# CITY OF ALBUQUERQUE

**Re: Sunport Apartments**  
Mulberry & Bethel  
Lots A1 thru F1 & Lots 1A, Block 10, Unit 3  
**Traffic Circulation Layout**  
Engineer's/Architect's Stamp 11-29-18 (M15D036)

Based upon the information provided in your submittal received 12-6-18, the above referenced plan cannot be approved for Building Permit until the following comments are addressed:

SUNPORT APARTMENTS  
SITE PLAN  
ALBUQUERQUE, NM  
PROJECT #1844

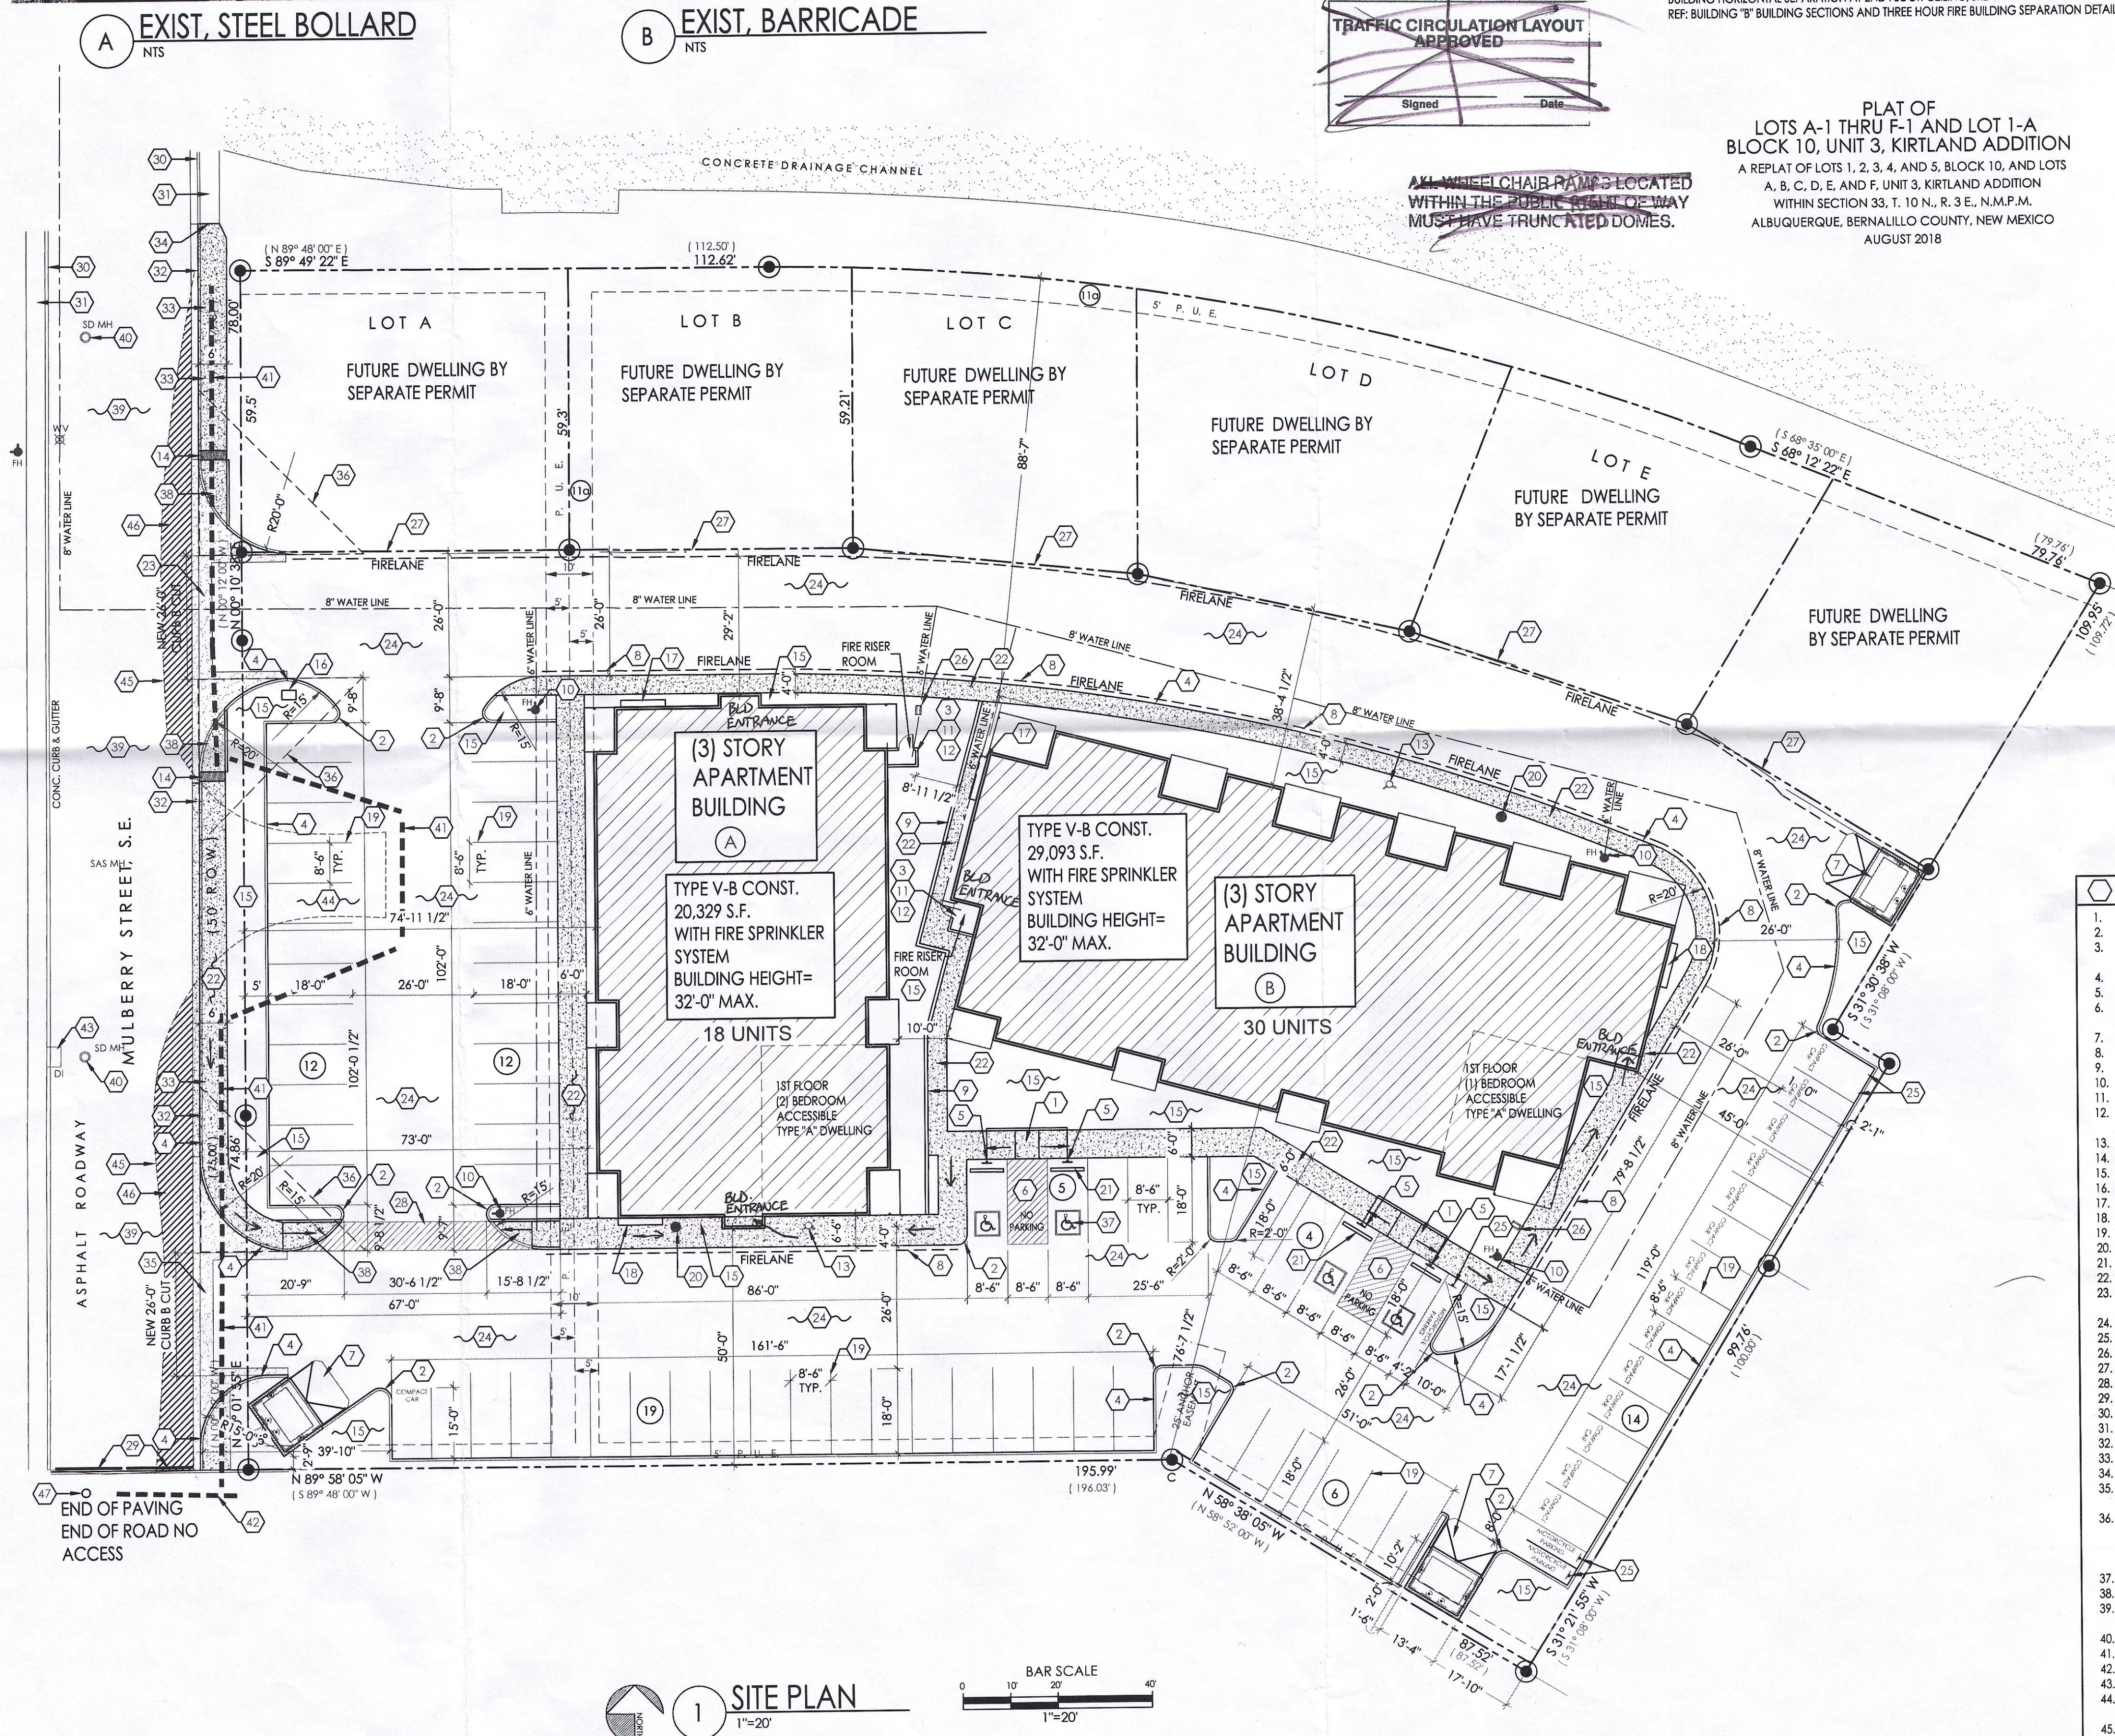
1. Please add truncated domes where necessary.
2. Corner of building on east side at building entrance cutting into walk path. Please correct 4' min.
3. Please provide copy of Final Plat.

Enclosure location o.k. Full review pending  
12-6-18 SWMD.
